Addendum No. 1 to Request for Quotes 2026-05

To: All Parties on Record with the City of Somerville as Holding Request for Quotes 2026-05
Electric Vehicle Supply Equipment and Installation at Somerville City Hall Concourse

Re: Answers to Questions

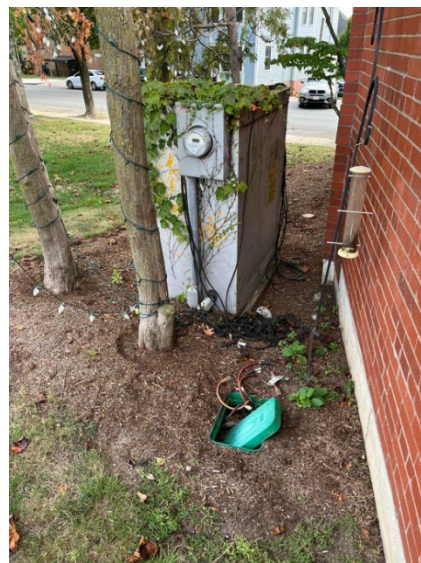
Question 21: Please provide pictures and the existing load of existing electrical service on site. Along with ampacity size, and voltage.

Answer: Photos of site and cabinet below.
